# UNITED STATES PATENT AND TRADEMARK OFFICE

APPLICATION NO.	FILING DATE	FIRST NAMED INVENTOR	ATTORNEY DOCKET NO.	CONFIRMATION NO.
10/517,205	12/08/2004	Niclas Rosberg	P08510US00/MP	5622

<b>Office Action Summary</b>	Application No. 10/517,205	Applicant(s) ROSBERG, NICLAS	
	Examiner Michael W. Talbot	Art Unit 3722

Fig. 1

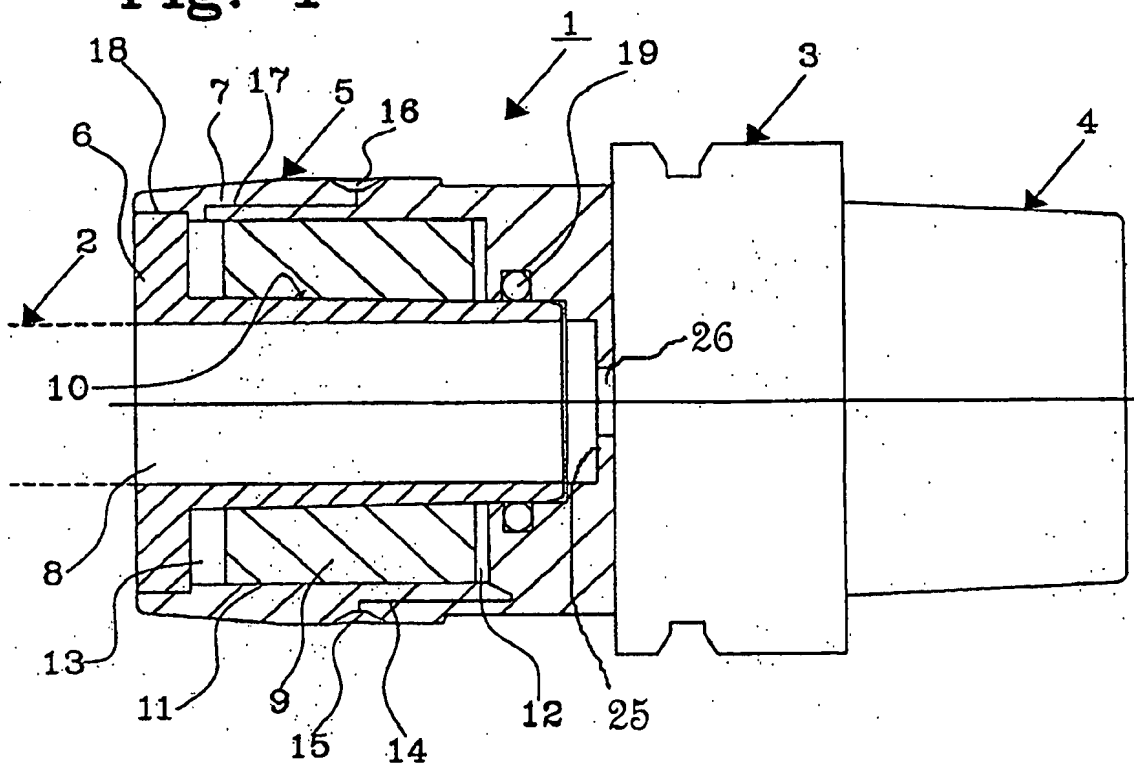
4. Claims 9,10 and 14 are rejected under 35 U.S.C. 102(b) as being anticipated by WO 84/04367 or, in the alternative, under 35 U.S.C. 103(a) as obvious over WO 84/04367. WO 84/04367 shows in Figures 1-3 a hydro-mechanical mandrel having one end for mounting in a machining device and having a second end for releasably holding a tool (a), wherein the second end further has a stop (surface/flange "k" best shown in Fig. 2 on left side) for preventing the tool from being inserted too far onto the mandrel. WO 84/04367 shows the mandrel comprising an inner sleeve (containing surface e) and an outer sleeve (containing surface f) enclosing at

least one chamber (c) in which a clamping means in the shape of an annular piston (d) is enclosed. WO 84/04367 shows the piston by means of hydraulically operating means is displaceable in an axial direction (page 5, lines 13-20), wherein the piston and the inner sleeve have respective contacting and interacting conical surfaces with each other (page 5, lines 10-13) having a conicity that is self-locking (page 5, lines 24-26), whereby axial displacement of the piston in one direction causes radial expansion of the outer sleeve for clamping the tool and axial displacement of the piston in another direction causes relief of the outer sleeve for releasing the tool. WO 84/04367 shows the chamber including a pressurized chamber (to the left side of piston d within chamber c as viewed in Fig. 1) and a relief chamber (to the right side of piston d within chamber c as viewed in Fig. 1). WO 84/04367 shows a sealing means in the shape of O-rings arranged between the piston and the outer sleeve (col. 5, lines 20-24).

In the alternative, regarding claim 1, the phrase "a mandrel having one end for mounting in a machining device and having a second end for releasably holding a tool" does not further limit the claim and is merely a functional/intended use statement not defining any specific structure. It should be noted that it has been held that a recitation with respect to the manner in which a claimed apparatus is intended to be employed does not differentiate the claimed apparatus from a prior art apparatus satisfying the claimed structural limitations. The only requirement is that the prior art reference be capable of said intended use. See MPEP 2114. In this case, WO 84/04367 discloses a structure fully capable of having one end (extreme right side of Fig. 2) being connected to a machining device and a second end (left side of Fig. 2) for releasably holding a tool regardless as to how well it performs.
